List of changes

Reviewer #1: The article "Timing performance of a micro-channel-plate photomultiplier tube" shows sound measurements of the timing performance of MCP-PMTs, if MIPs traversing the detector window. It is shown that the performance at the MCP-PMT edge is worse, mainly due to bad Cherenkov photon collection. The experimental data is presented in a compelling way and theoretical considerations are given to explain the measurements. Personally I like the analytical model and would extend it to account for multiple reflections, keeping only one fit parameter. The Monte-Carlo simulation seems to be over-fitted and a reduction of the free parameters would be good. In the introduction I suggest to include a bit more the work of other groups. Many people are using MCP-PMTs as reference detector and have studied the performance, there are as well other options for fast reference detectors.

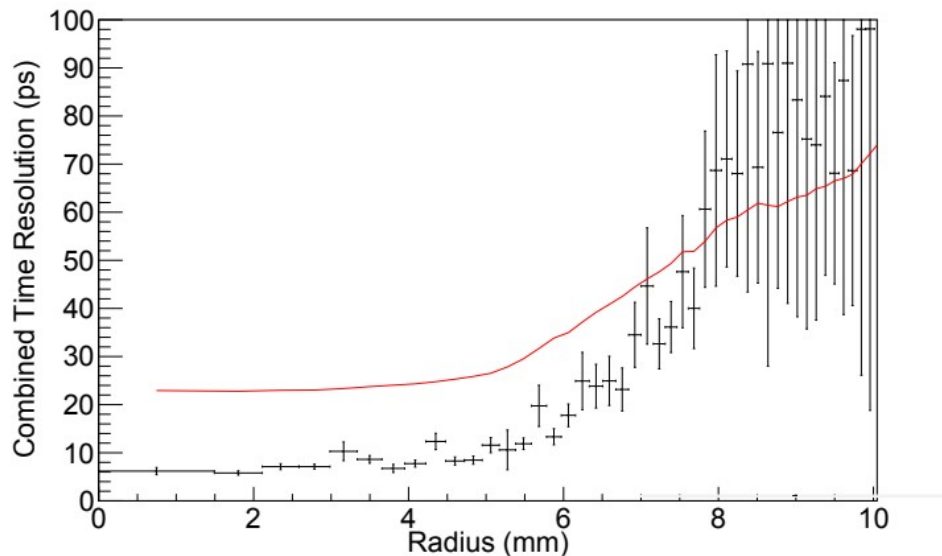
Equation 3: To me this equation seems weird. Should the first term not be: $\sigma_{MCP1}^2 \cdot (N_0/N)$. Thinking that the time resolution in the center is σ_{MCP1} , where all N photons are detected. On the edge only N_0 photons are detected, which then gives the ratio in the equation. Similar for the second term. Besides, I do not think you can just add these two terms like that. There are surely cross-correlations, which have been omitted.

This is the equation to calculate the squared time resolution of one MCP-PMT with the simulated number of photons reaching the photocathode. N_0 means photons with 0 reflections and N_1 are photons after one reflection circle (reflection on photocathode, reflection on air-interface, no reflection or absorbtion on photocathode). In the center of the photocathode $N_0 \rightarrow N$ and $N_1 \rightarrow 0$. The time resolution for each mcp is then calculated by $\sqrt{(N_0/N)^2 \cdot (A/N_0) + (N_1/N)^2 \cdot (B/N_1)}$. The combined time resolution is calculated by $\sqrt{\sigma_{mcp1}^2 + \sigma_{mcp2}^2 + \sigma_{daq}^2}$. Please find attached the simulation with $\sigma_{mcp1}^2 = (N_0/N) \cdot (A/N_0) + (N_1/N) \cdot (B/N_1)$.

Both terms are certainly correlated. 1. they use the same N and 2. B is defined by A. While σ_{mcp1} and σ_{mcp2} are treated as two separate detectors with aligned center to each other. This means that the charge distribution is similar to both but the simulation is done separately.
